Technical Newsletter

No:
41:2

SMART kit replacing all previous versions of motor protection 50 034 xx & 50 905 xx - series

Electrical connection diagrams for 50 034 XX-serie (Proline pumps)

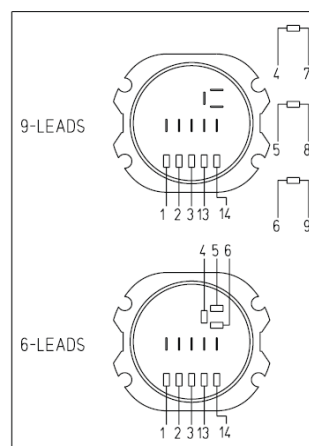
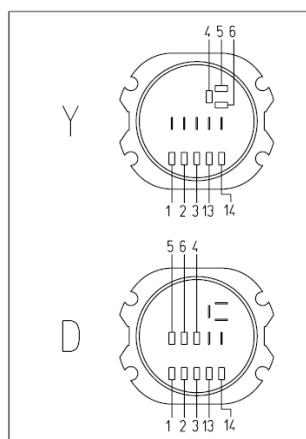
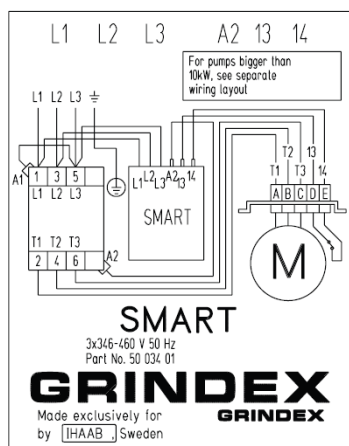
When replacing p/n 50 034 XX with kit p/n 51 666 XX, always mount jumper strip on 15-16 and connect 13-14 according existing diagram in the pump. For pumps above 10 kW see individual connection diagram for 13-14.

L1-L2-L3 on the SMART is changed to F-G-H

Connect -

L1 to F
L2 to G
L3 to H

13-14 to thermal contacts (TC)

15-16 to jumper strip

Electrical connection diagrams for 50 905 XX-serie (81XX-pumps)

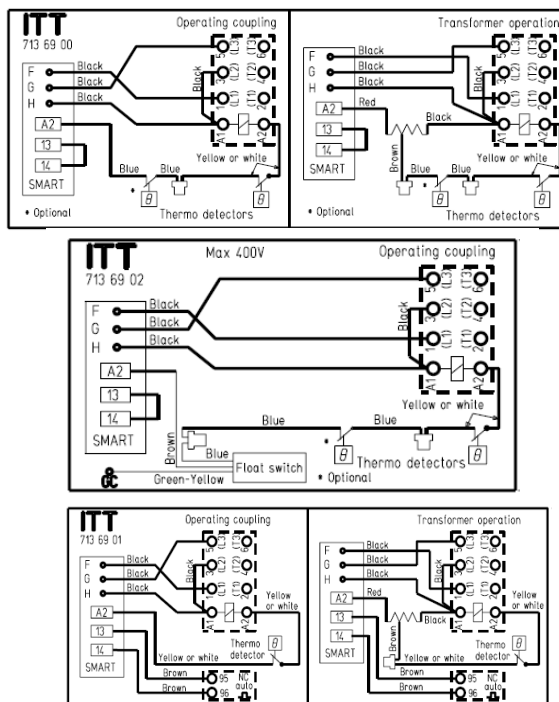
When replacing p/n 50 905 XX with kit p/n 51 666 XX kit

On Minex-Major, Salvador-Sandy pumps standard and with built in float switch both 13-14 & 15-16 should have jumper strip mounted (see upper & middle diagram),

On pumps with overload relay connect 13-14 to overload relay & 15-16 with jumper strip (see middle diagram).

Connect -
Minex-Major, Salvador –Sandy
Standard and with built in float switch
13-14 to jumper strip)
15-16 to jumper strip
F-G-H is connected as wiring diagram

Connect -
Master-Matador
13-14 to Overload relay (OR)
15-16 to jumper strip
F-G-H is connected as wiring diagram
